Final Set, Jefferson Village Phase II  
(Bulletin 6)

JEFFERSON VILLAGE

TYPICAL PAVEMENT CROSS SECTIONS

HOR. SCALE: NO SCALE  
VER. SCALE: NO SCALE  
DATE: 3-27-00  
JOB NO.: DE99011  
FILE NO.: DE9911X1  
SHEET NO.: P-0.2

APPROVED BY: *M. Hamood*  
 MAY 07 2001  
 A CITY ENGINEER AND DESIGNER  
 IS REQUIRED FOR ALL LOCAL WARDEN  
 STREET RIGHT OF WAY

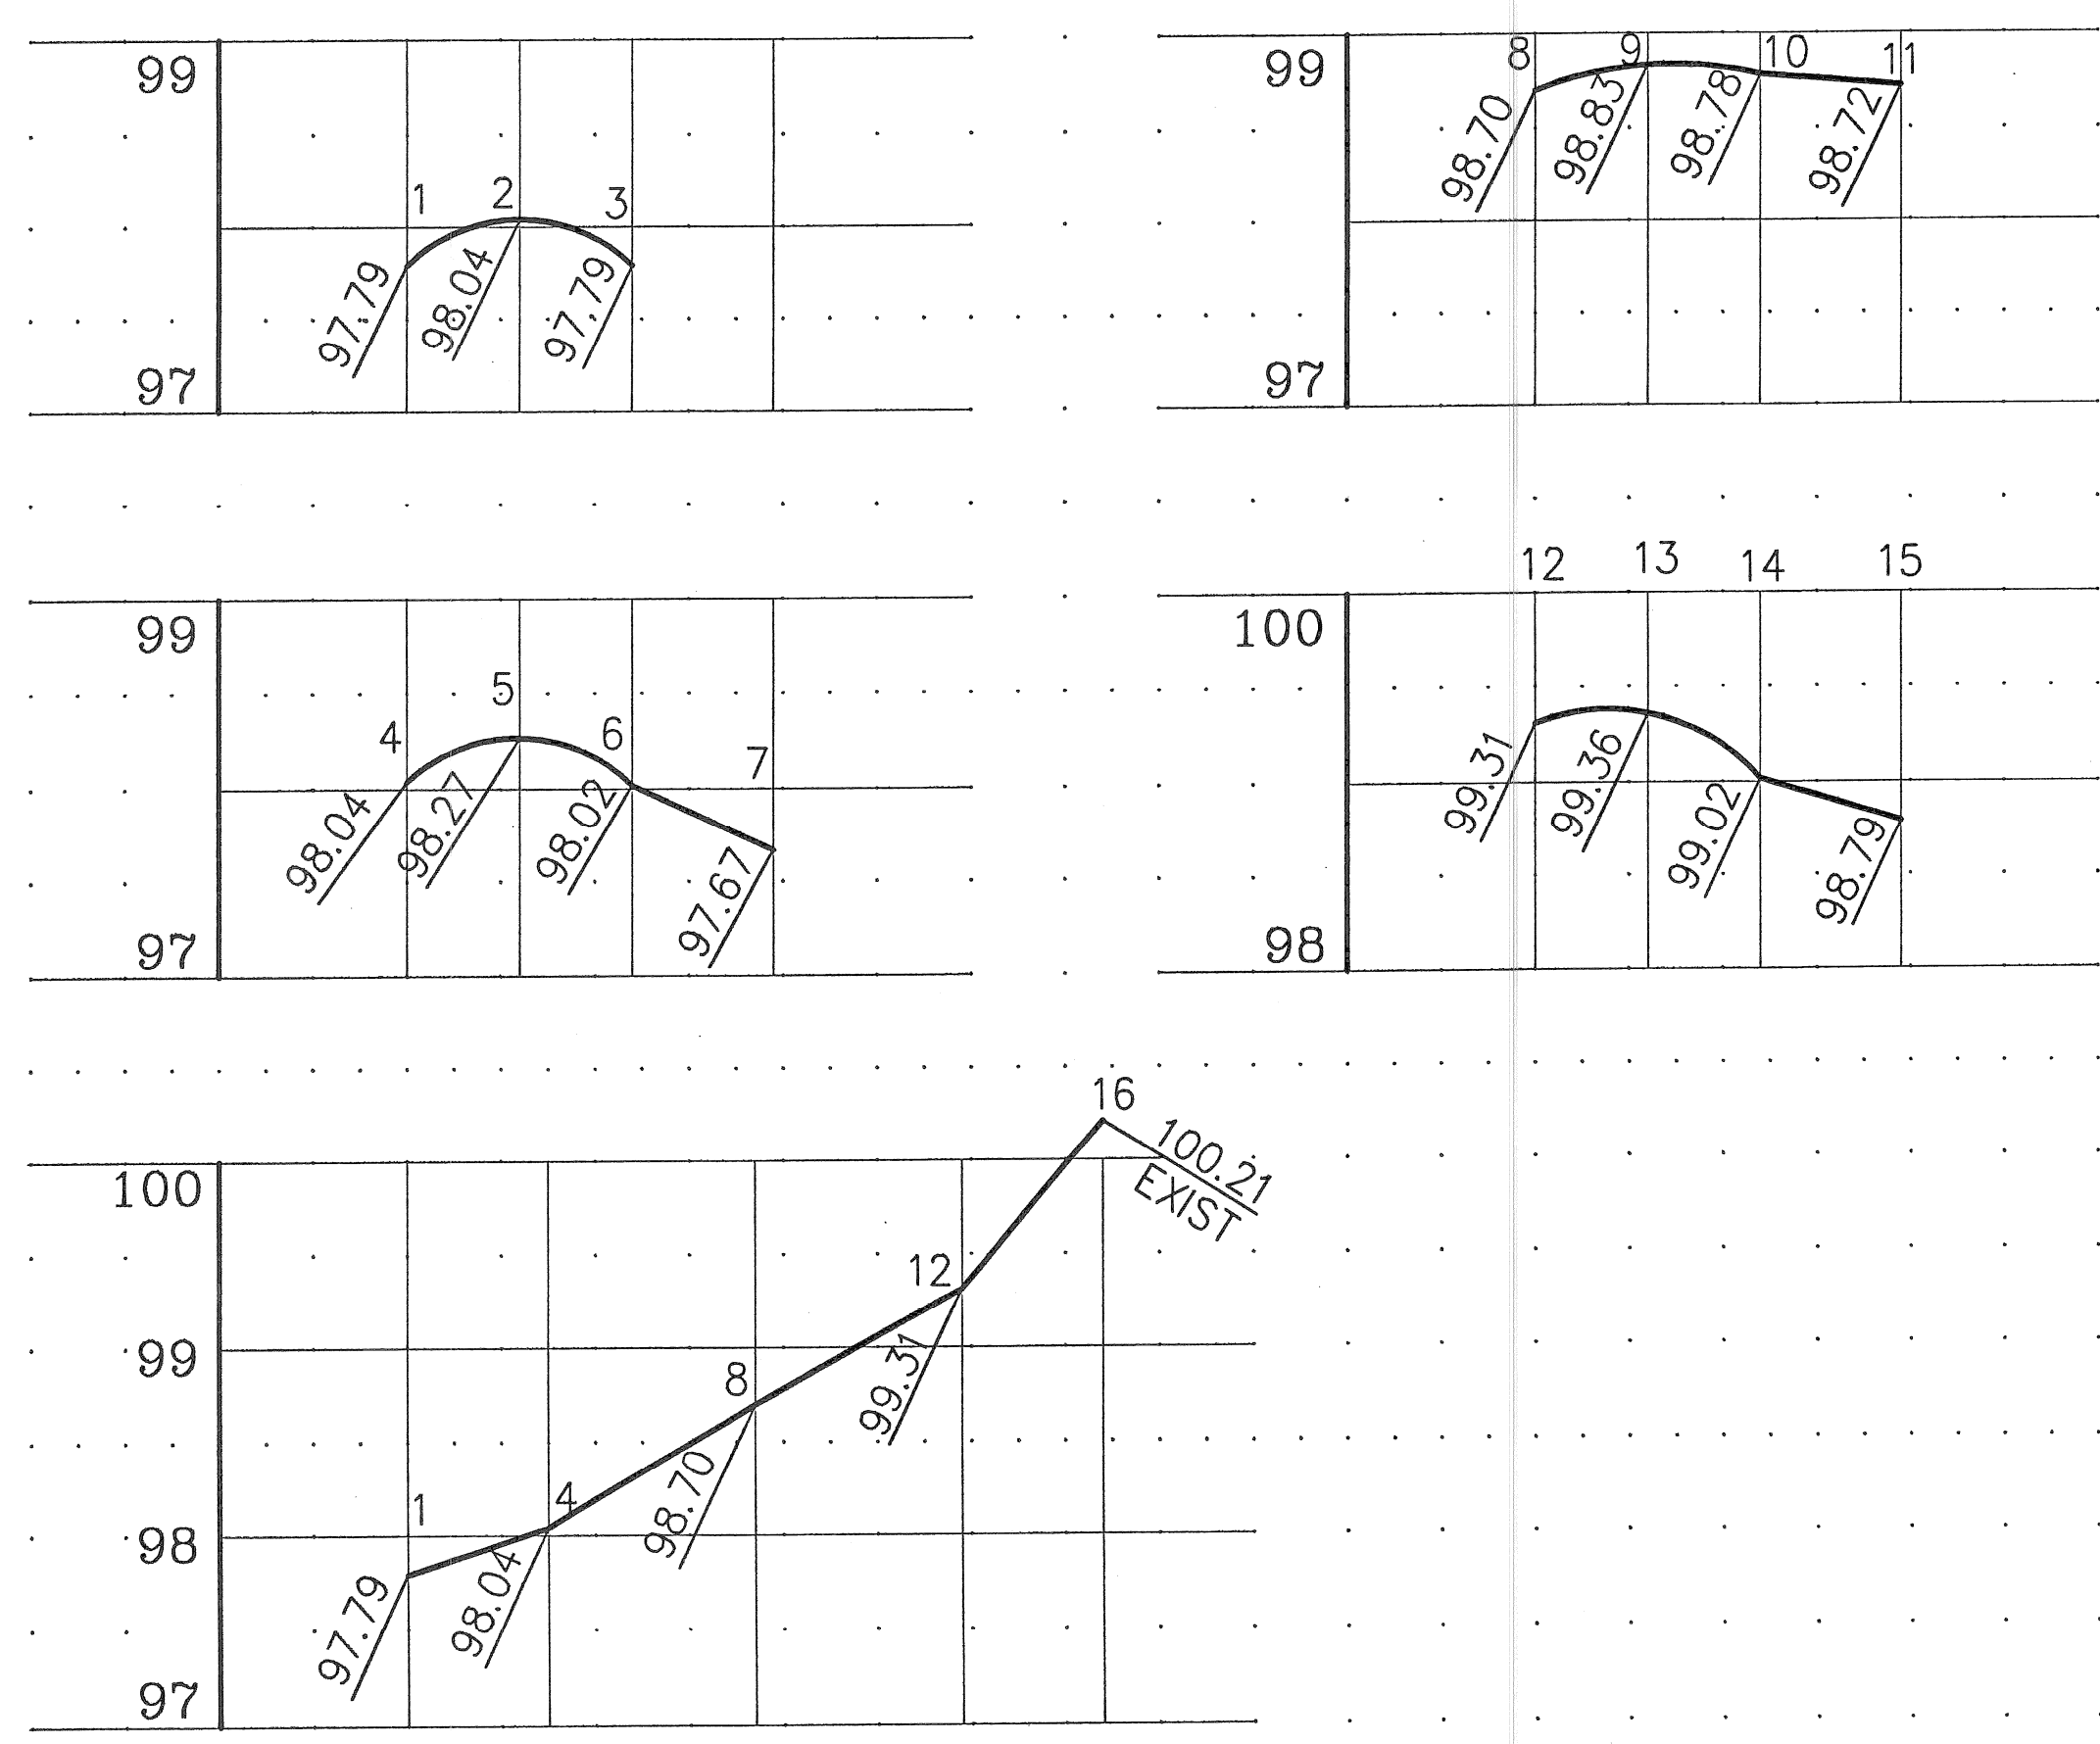
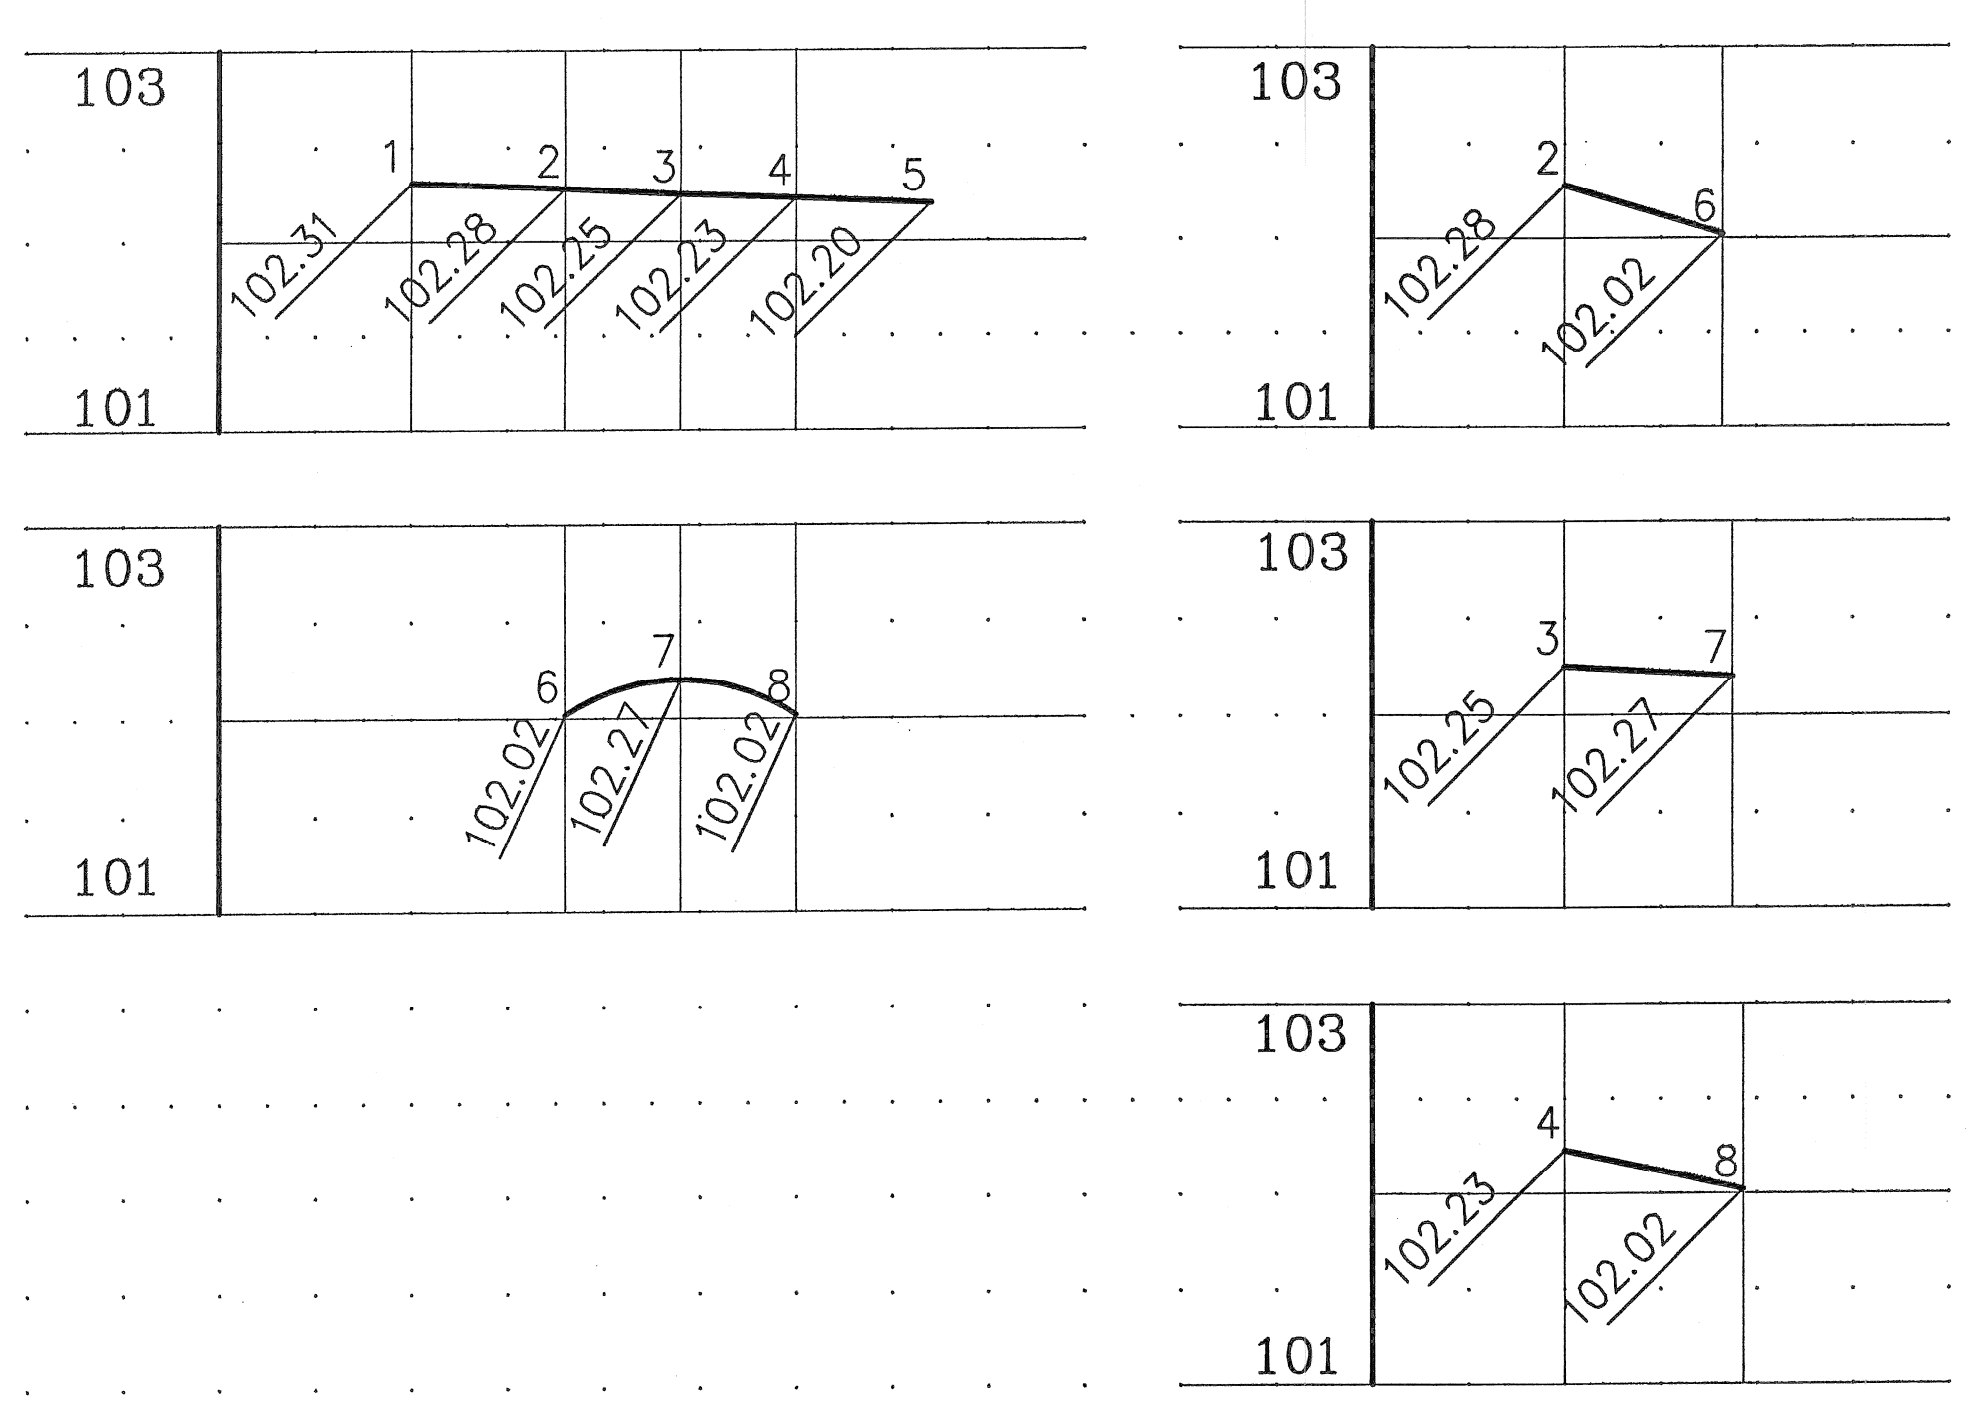
**NOTE:**  
 WHERE PROPOSED ROLL CURB TIES INTO EXISTING CURB/7" HIGH CURB THE CONTRACTOR SHALL TAPER DIMENSIONS OF THE PROPOSED CURB OVER A LENGTH OF FIVE (5) FEET TO MATCH THE EXISTING/7" HIGH TOP OF CURB, FACE OF CURB AND BACK OF CURB. PAYMENT FOR THIS WORK SHALL BE CONSIDERED AS BEING INCLUDED IN THE COST FOR ALL OTHER CONCRETE PAVEMENT WORK.
